Subject: AK Steel Dearborn Works – Civil Action No. 15-cv-11804
DJ # 90-5-2-1-10702

OPERATIONAL REVIEW REPORT

ELECTROSTATIC PRECIPITATOR

**AK Steel
Dearborn, Michigan**

Figure 1: B Vessel water sprays

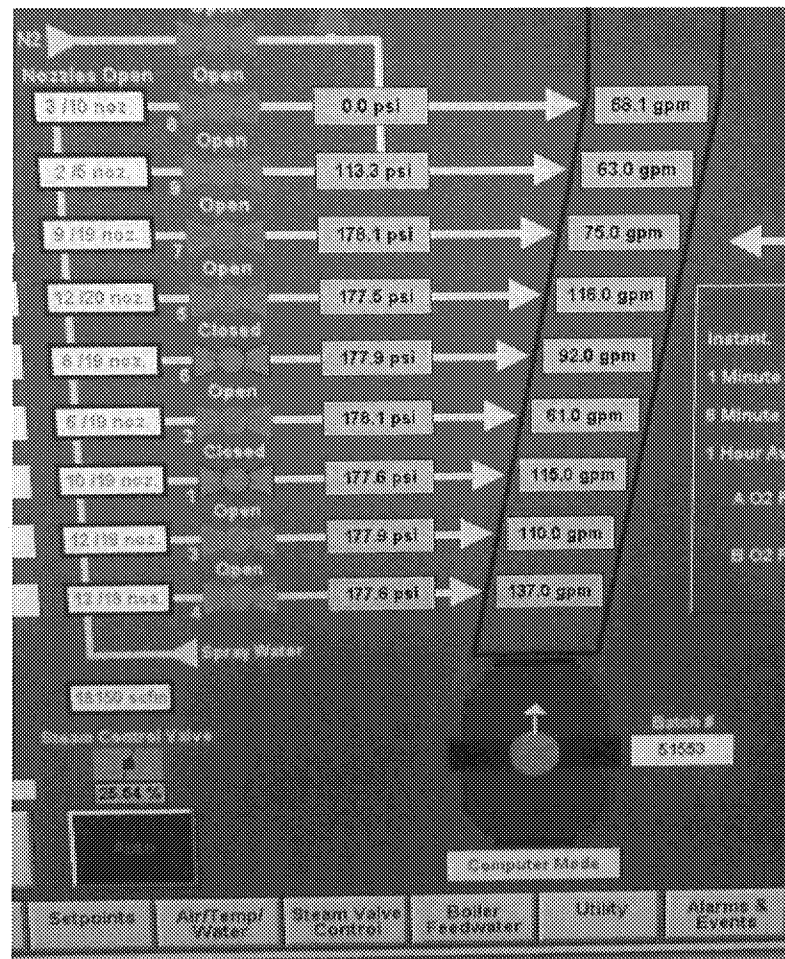
The actual condition of these nozzles is unknown. The listing on the left side of the following picture indicates that many nozzles are out of service. Based on the flows, I suspect this is correct. In watching the operation, it was noted that all the spray banks now operate on most heats. This is unusual. In previously observed conditions, spray banks 3 and 4 almost never turned on. These could be referred to be emergency nozzles, since they would operate only during a heat that was unusually hot. This allowed the system to accommodate problem heats. With all the nozzles in normal operation, the system has no reserve for a runaway heat. This would mean that a hot heat would cause a furnace trip.

As can be seen in Figure 1, the flow through each of the 1-7 banks of sprays are between 63 and 137 gpm. With all the nozzles in full operation, there would be approximately 150 gpm at each operating spray bank. Under normal conditions, 120 gpm per operating spray bank is common. By reducing the flow through each bank of nozzles, the system is simply forced to operate at a higher temperature in order to turn on successively more nozzle banks. This results in an average heat such as above operating with every bank in operation.

The problem with this type of operation is that any failure of one valve or any "hot" heat will simply trip the furnace and open the roof stack.

In the past, each of the spray banks 1 through 7 were operated at 120-150 gpm with new nozzles, and then once in operation, the boiler maintenance crews would locate the two nozzle banks that operated near equilibrium and adjust the flow of those two banks to provide smooth temperatures. Generally, nozzle banks 7 and 5 operate through the majority of every heat, and banks 6, 2, and 1 operate during the last half of each heat. Under normal conditions, banks 3 and 4 were not used except as backups. Some of the extended water flow may be attributable to higher blow rates than previously observed creating higher heat loads on the system.

- 6.1.1. Investigate the air flow system on the bank 8 sprays.
- 6.1.2. Maintain a flow rate of 120-150 gpm through spray banks 1-7.
